ADDENDUM NO. 2:

Date: 09/10/26
 Project: L.E. WILLSON ES WINDOW REPLACEMENT
 WSM #26-026
 DCM# 2026579

Owner: Sheffield City Schools
 Architect: Ward Scott Morris Architecture, Inc.

1 GROUND LEVEL - OVERALL EXISTING PLAN
1/16" = 1'-0"

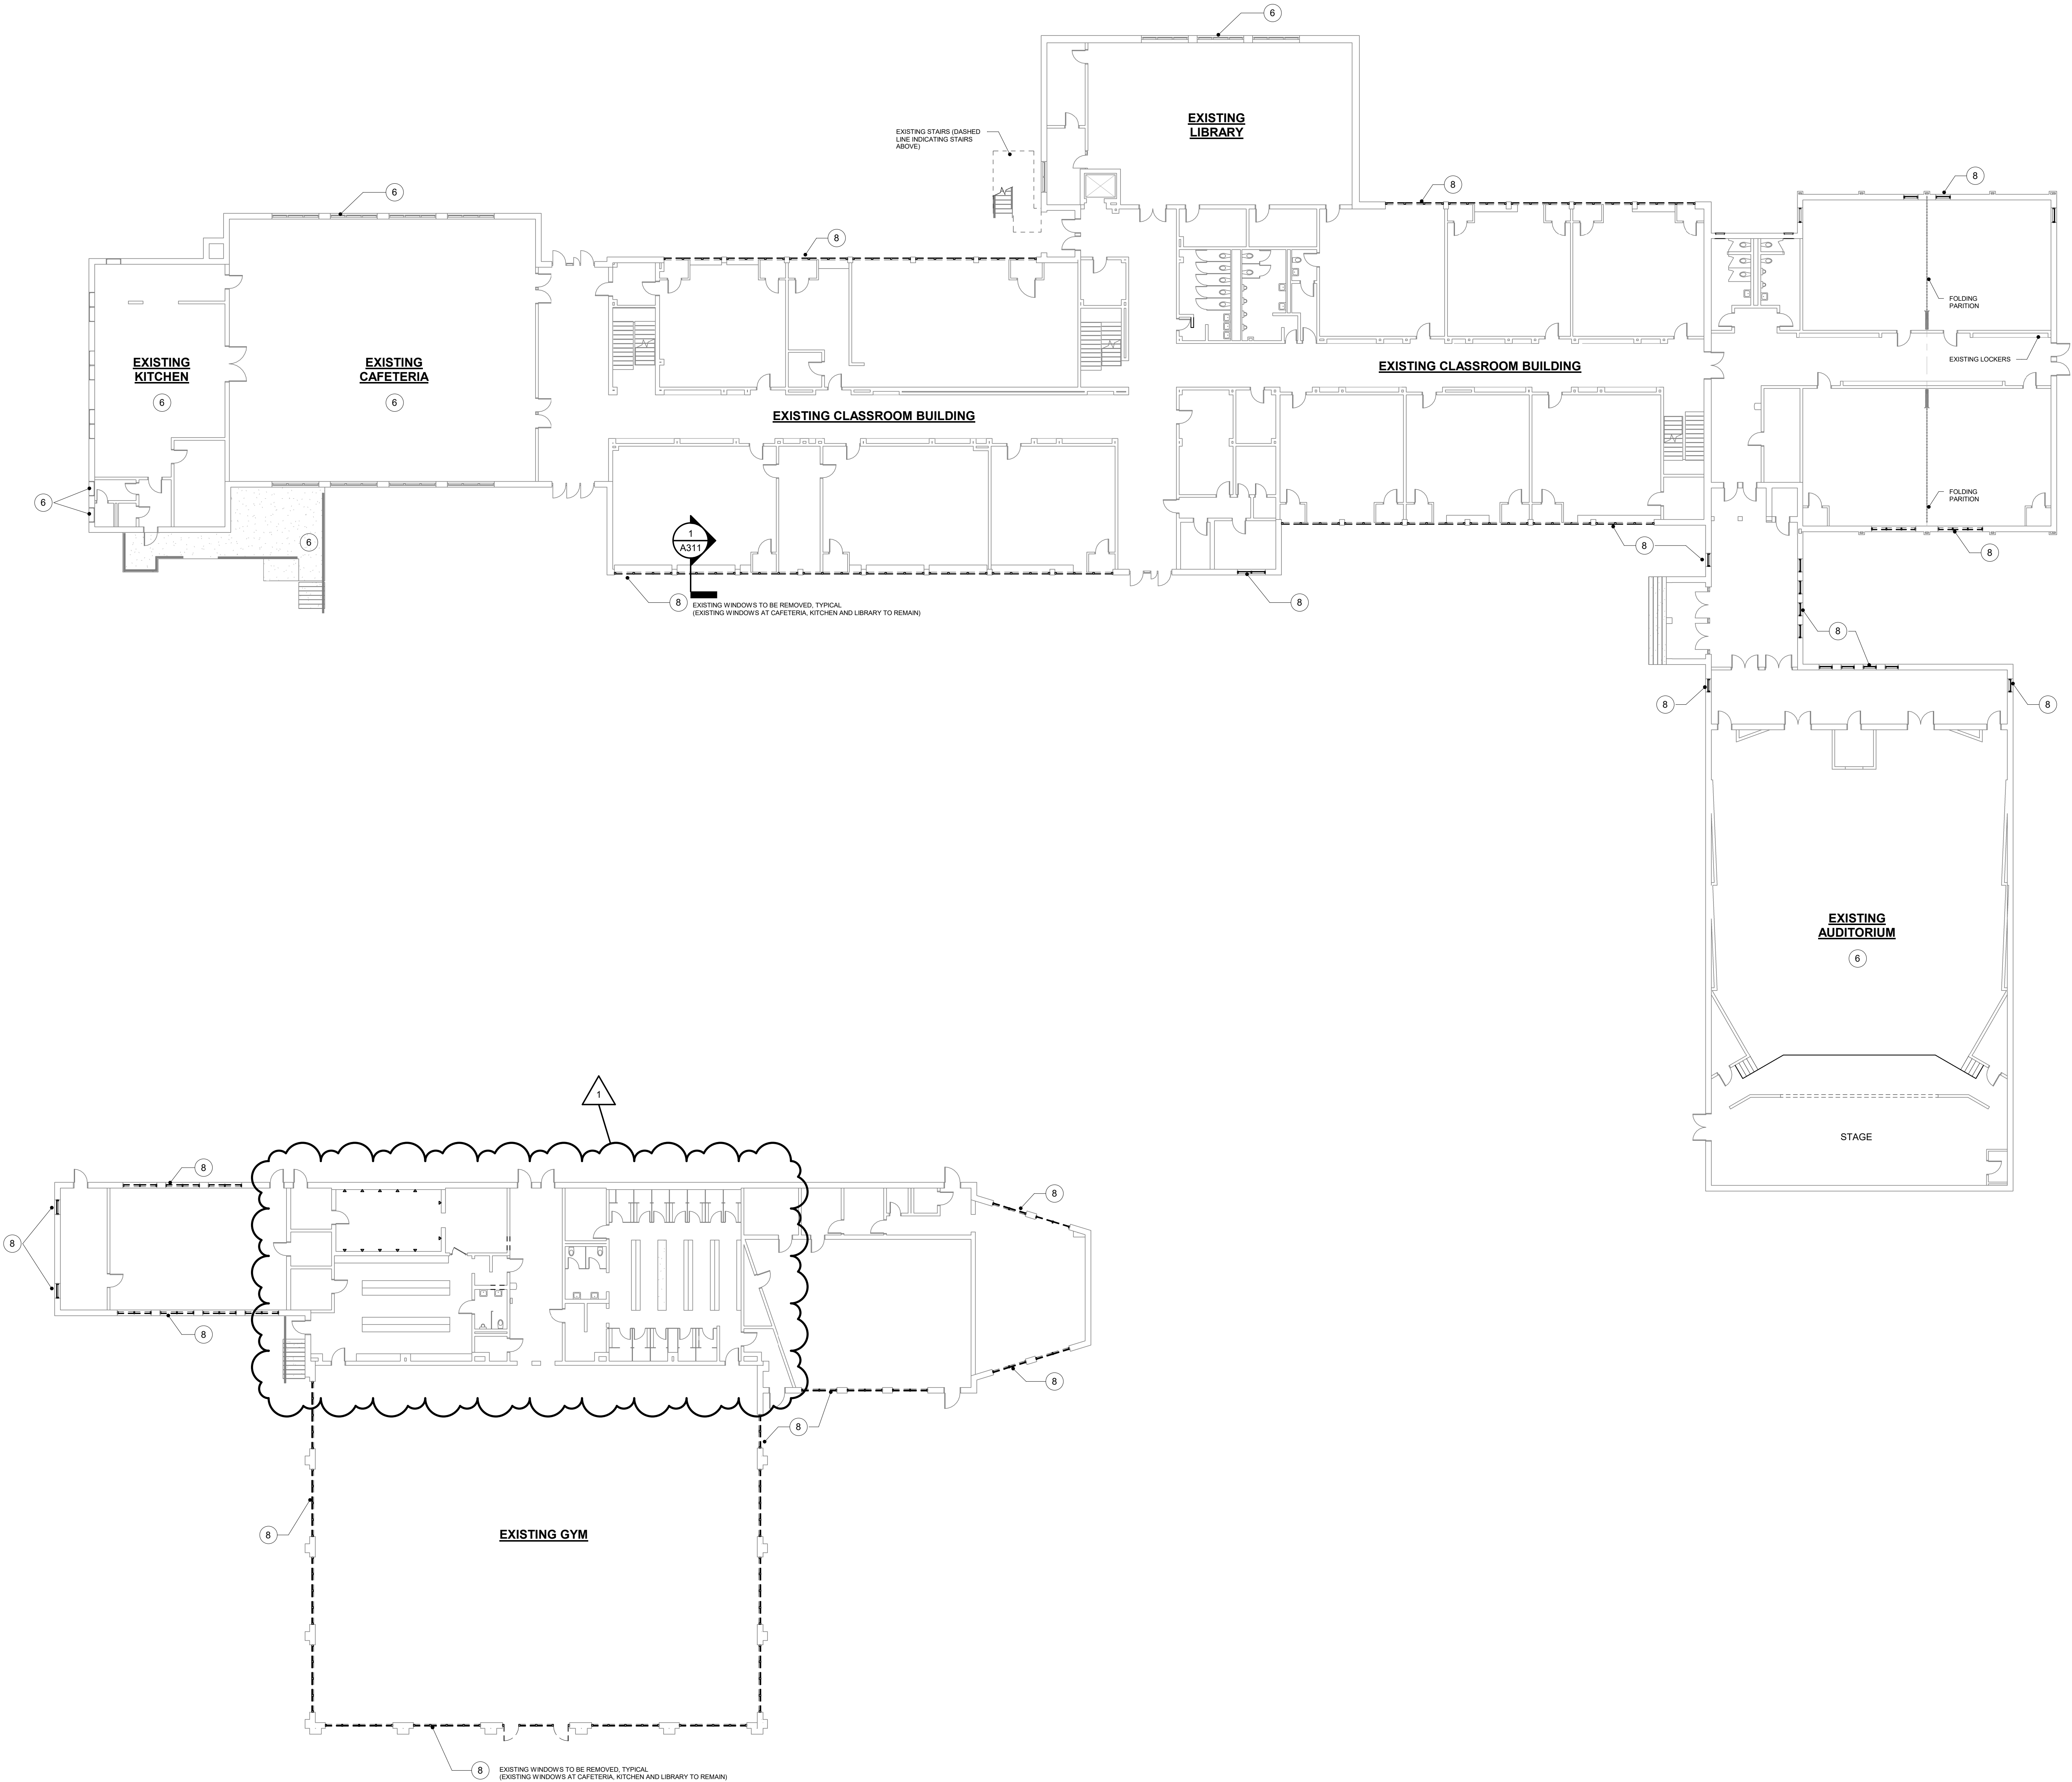
- A. Demo and Reno of the gym locker rooms has been removed from the scope. Please note sheet removal listed below.
- B. On Page A001 there is a note "SPANDREL GLAZING TO COVER SIDE OF WINDOW THAT COVERS INTERIOR MECH ROOMS" does this apply to the classroom windows and classroom closet windows? Please Advise.
 1. Spandrel to be located as indicated on window elevation sheets. The spandrel layout on these sheets should cover all mechanical closets from exterior view. Note adjusted for clarification on attached A001.
- C. Please provide the door hardware schedule.
 1. Please provide hardware allowance of \$1800 per door.
- D. We have noticed that there are three Plan pages listed on the Index that are missing: A094, A104, And A105. In addition, there is one that was included in the documents but is not listed on the Index: A331. Please, advise.
 1. See below for revised sheet list.

OVERALL NEW
CONSTRUCTION
PLAN - GROUND
FLOOR

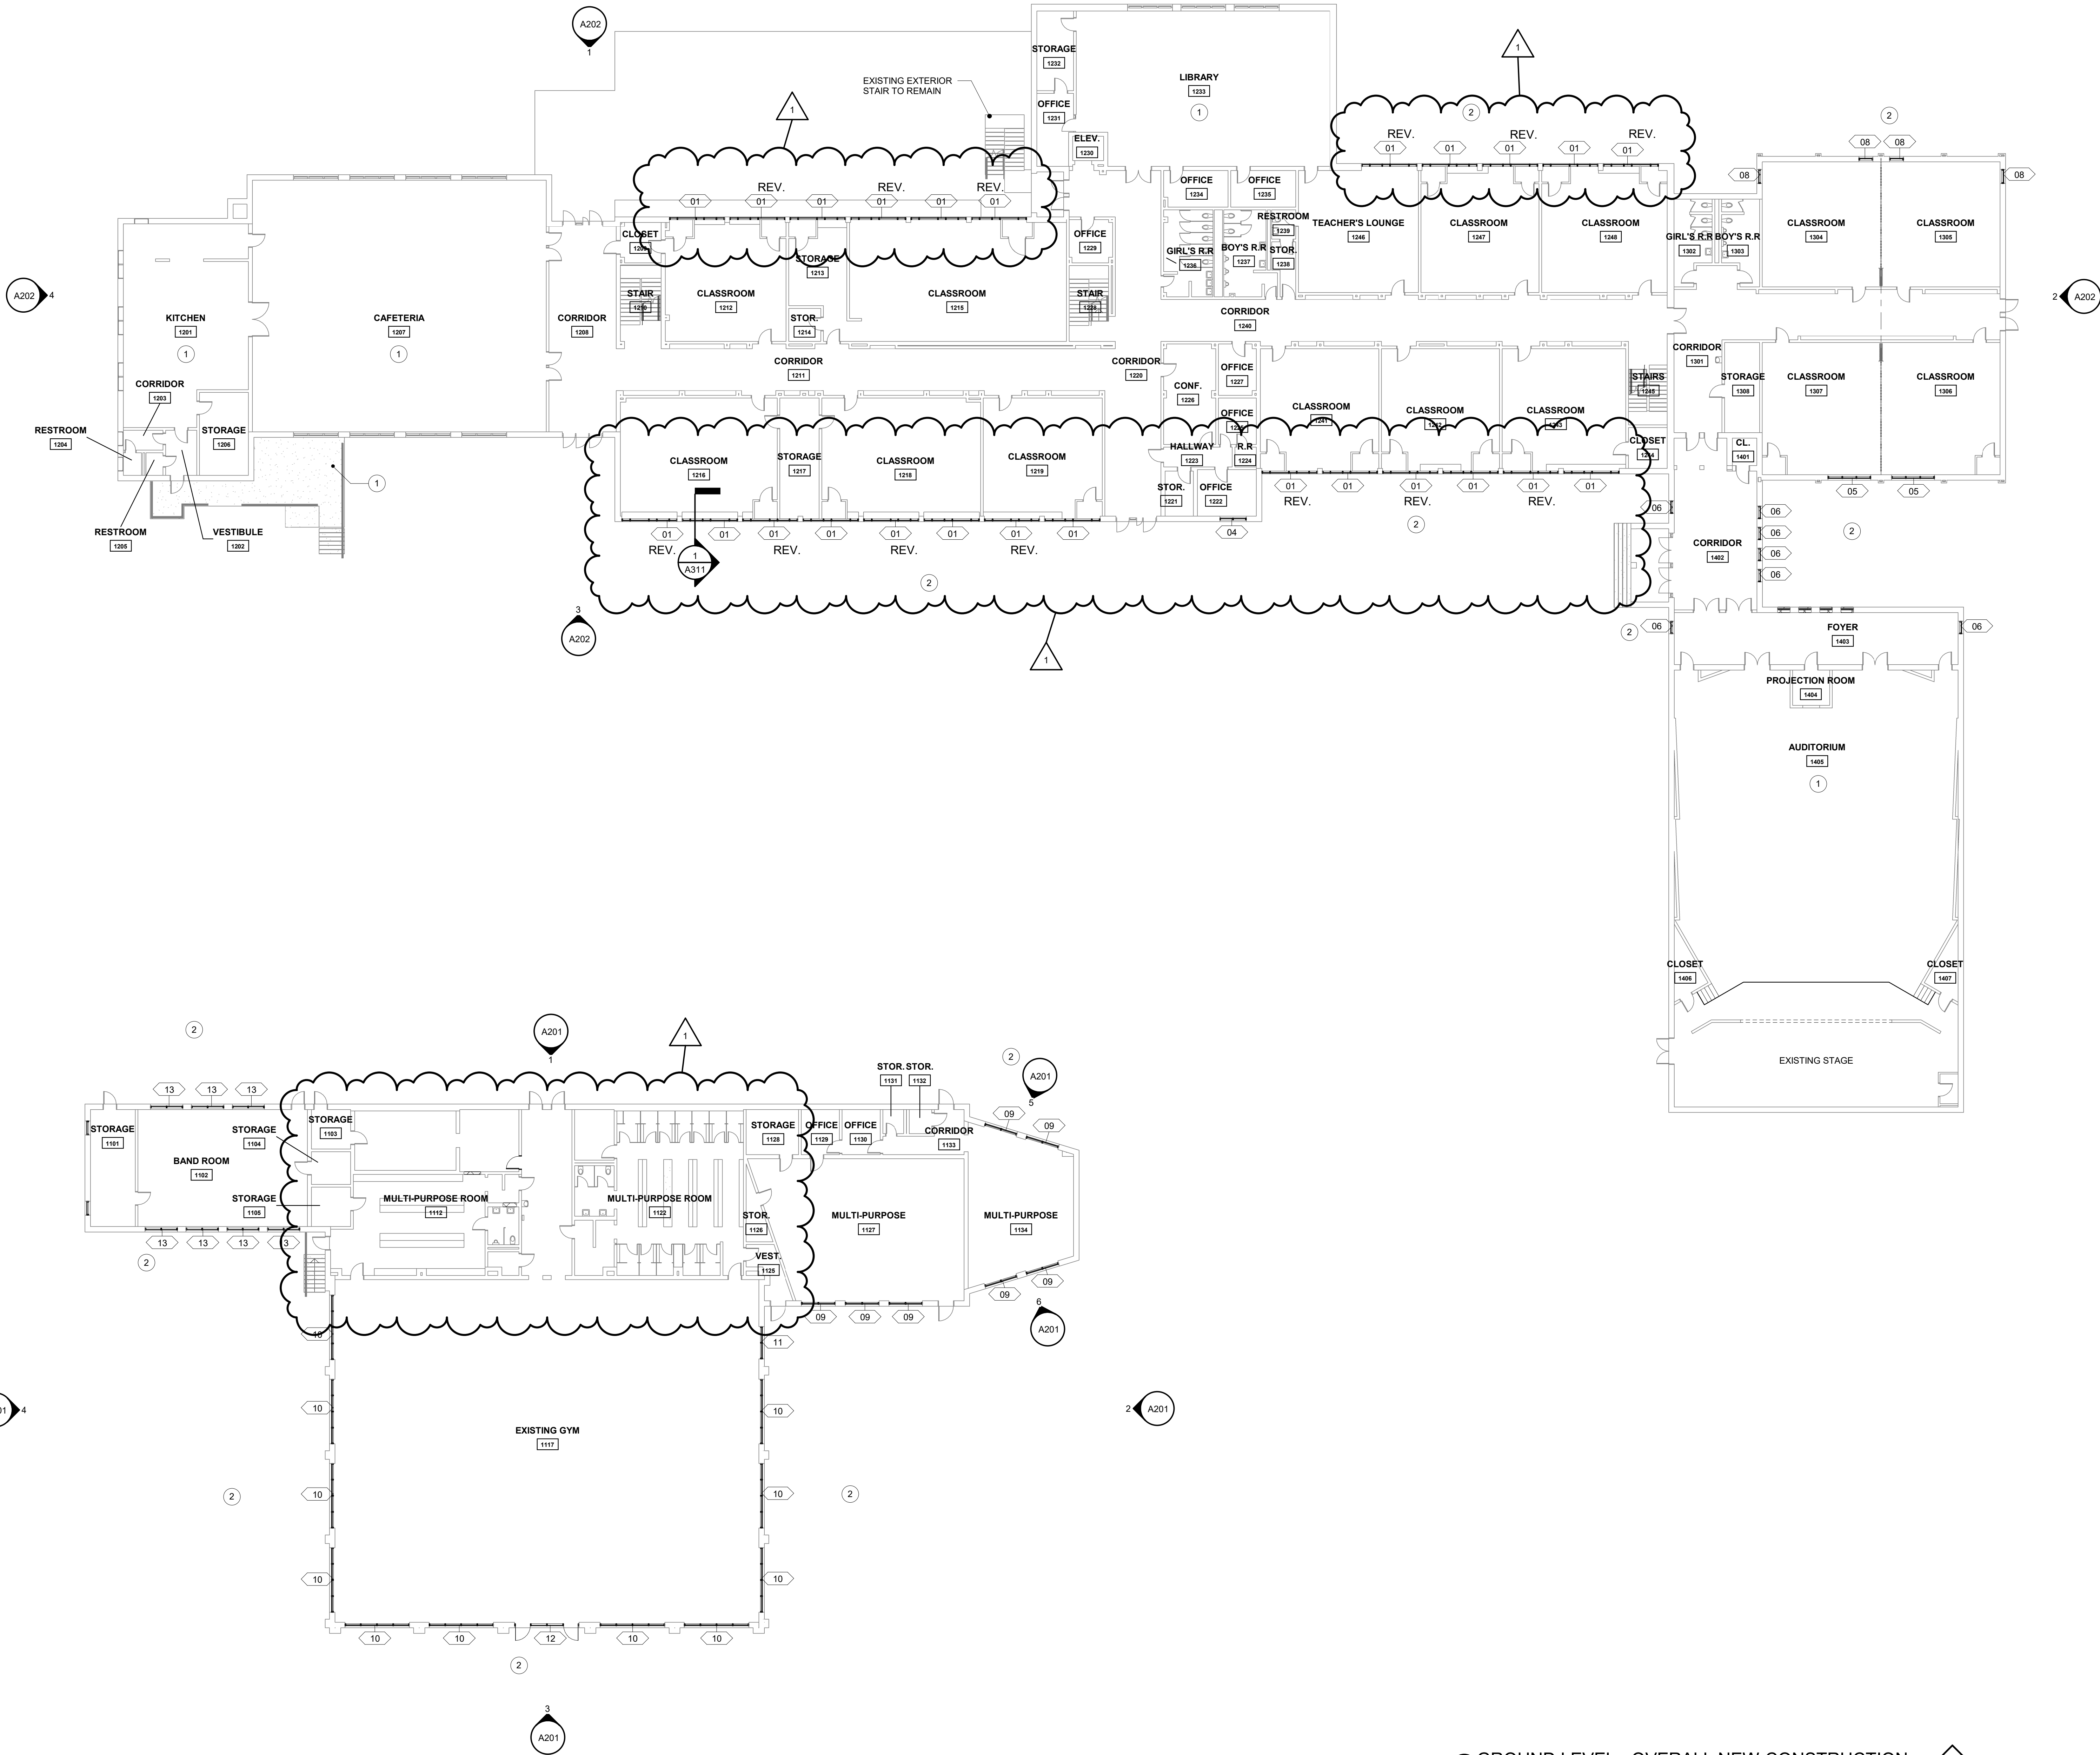
ADD 2: REMOVED GYM LOCKER DEMO/RENO SCOPE, ADDED MISSING TAGS
